Project	IEEE 802.16 Broadband Wireless Access Working Group < http://ieee802.org/16 >	
Title	Fast MSS-BS DL Data Flow Coordination for FBSS Support	
Date Submitted	2004-11-15	
Source(s)	Hang Zhang, Bill Gage, Shalini Periyalwar, Mo-Han Fong Nortel Networks mhfong@nortelnetworks.com Mary Chion mchion@ztesandiego.com ZTE San Diego Inc Min-Sung Kim cyberk@kt.co.kr KT	Deleted: 04 Deleted: Tel: +1 613 765-8983 Fax: +1 613 765-6717 Deleted: ¶ Deleted: ¶
Re:	IEEE P802.16e/D5-2004	
Abstract	A fast signaling mechanism is introduced to identify the next information unit to be transmitted by a new anchor BS while the MSS is in FBSS handoff. This is a revised contribution. Changes are highlighted in blue.	Deleted: 1
Purpose	Review and Adopt the suggested changes into P802.16e/D5	
Notice	This document has been prepared to assist IEEE 802.16. It is offered as a basis for discussion and is not binding on the contributing individual(s) or organization(s). The material in this document is subject to change in form and content after further study. The contributor(s) reserve(s) the right to add, amend or withdraw material contained herein.

Figure 1: SN Report Header Format

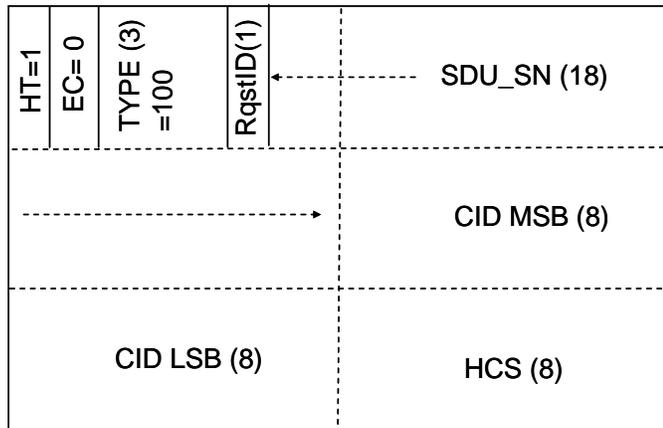
[Add a new section 6.3.2.1.6]

The SN Report Header shall be of the form illustrated in Figure 1. The SN Report header shall have the following properties:

- a) The length of the header shall always be 6 bytes
- b) The EC field shall be set to 0, indicating no encryption
- c) The CID shall indicate the basic connection of the MSS for which the SN Report is being sent.

- d) The SDU SN field shall indicate the LSB of the next ARQ BSN or the virtual MAC SDU Sequence number for the active connections. The LSB of the ARQ BSN or virtual MAC SDU sequence number for each connection is provided. At most 3 SNs can be provided in each SN Report Header in numerical ascending order of the CID values of the connections with sequence number feedback enabled.

- e) The RqstID field may be used to indicate whether the SN Report header is the first or second of two consecutive SN Report headers, to accommodate up to 6 active connections. The fields of the SN Report header are defined in Table 1. Every header is encoded, starting with the HT and EC fields. The coding of these fields is such that the first byte of a MAC header shall never have the value of 0xFF. This prevents false detection of the stuff byte.
